## Report to Planning and Environment Committee

**Subject:** Farhi Holdings Corporation (c/o Jim Bujouves)  
192-196 Central Avenue  
File Number: Z-9695, Ward 13

**Date:** March 19, 2024

Figure 3 - Conceptual Site Plan (January 2024)

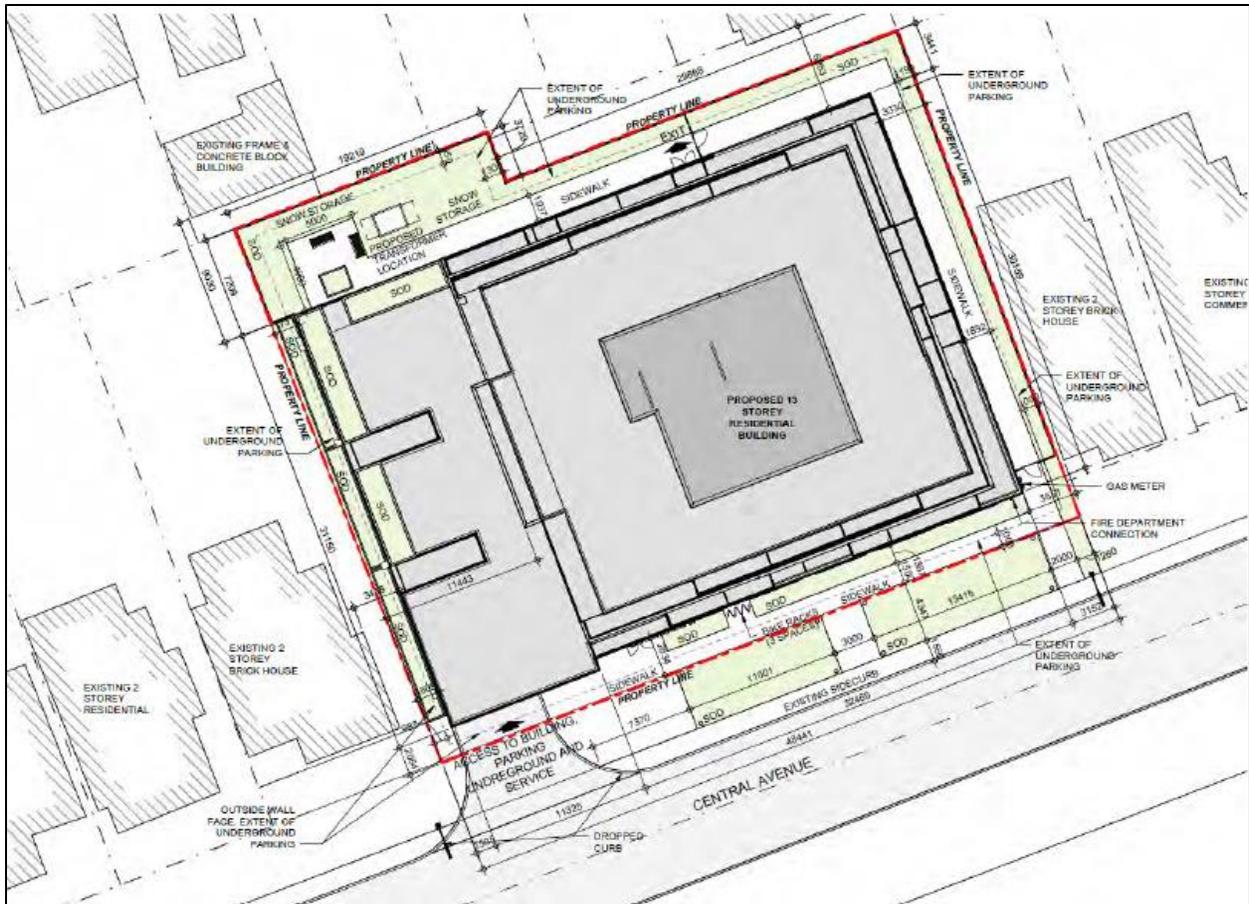
- One meter setbacks have been provided between the underground parking structure to west, north and east property lines. These setbacks will not meet Site Plan Control Bylaw requirements of 1.5m landscape strips. Soil volumes will be insufficient to support required tree planting along interior property lines.
- An area of significance for tree planting is between the raised amenity area and the residence immediately to the west. Vegetative screening is required, possibly in the form of columnar trees.

- The current plan indicates that the underground parking structure is less than the required 1.5 metres from all property lines. Revise these setback distances to allow for landscape screening.

- Widen the access driveway to a minimum of 6.7 metres as is required for residential developments.
- The proposed snow storage strategy presents conflicts with proposed landscaping and functionality, provide further clarification regarding how snow storage will be handled on site.

Figure 6: 192-196 Central Avenue Landscape Plan (January 2024)

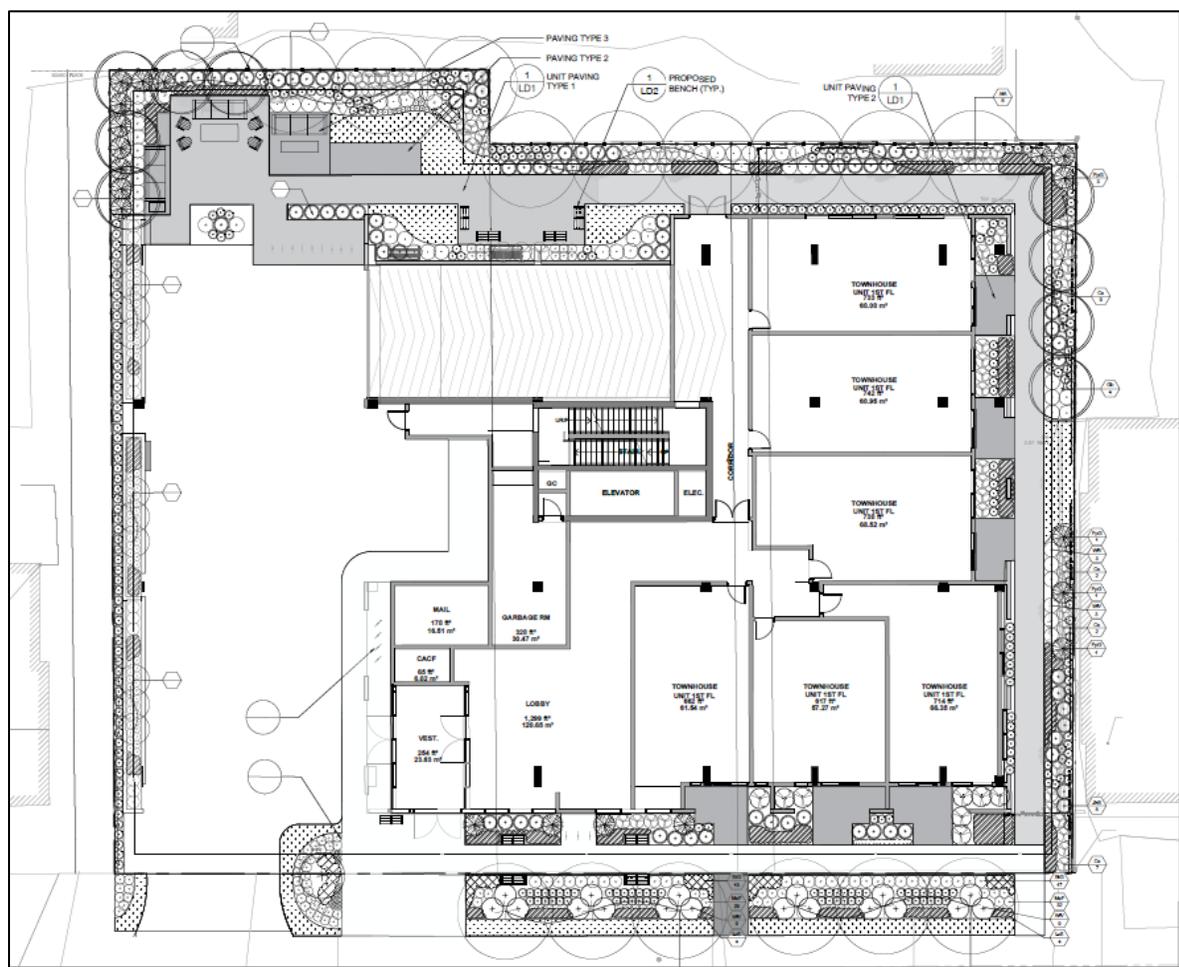
<b>Comment:</b>
Consider placing the walkway on the east side of the building further east adjacent to the fence. This will allow for a larger landscape buffer for the ground floor units and a better opportunity for the landscape to grow and flourish.
<b>Applicant Response:</b>
8 This comment will be considered through the ultimate site plan application, where the landscape design will be confirmed.

MARCH 21 & JUNE 21 - IMPACT TO 187 HYMAN STREET- For DISCUSSION PURPOSES ONLY  
 192 Central Avenue Shadow Study • London, ON

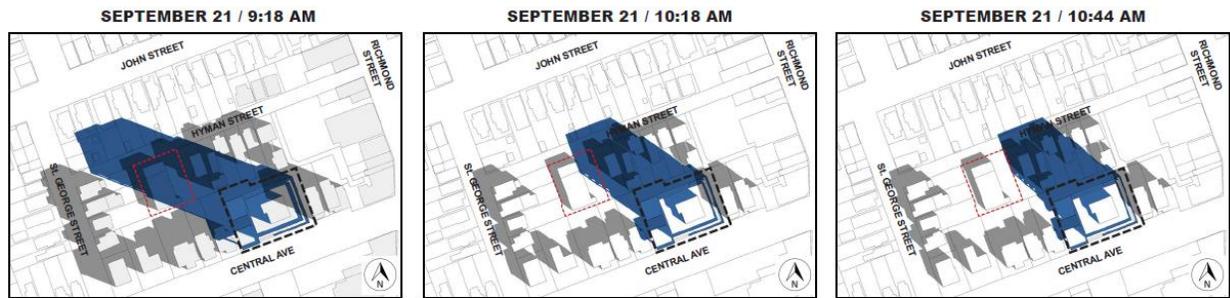
The shadow study was based on the applicant's development concept and not the potential maximum building envelope that would result from the building setbacks requested by the applicant, which would have cast a larger shadow. The shadow study demonstrates that the potential shadow produced by the applicant's development concept (SMR Architects November 21, 2023) consistently shadows all or portions of our principal outdoor amenity area located on the east side of our property in the morning hours on a year-round basis. We believe that although this level of shadowing exceeds the shadowing that would be produced by the existing By-law, it remains acceptable to us. Based on the shadow study, we believe that if the proposed tower (13-storey) element was allowed to be setback only 3.0 metres from the west property line, which would be possible based on the amendment requested by the applicant, as opposed to the 11.443 metres shown in the applicant's development concept, the resultant shadowing on our outdoor amenity area would be more extensive and continue for a longer duration daily, and would be of concern to us.
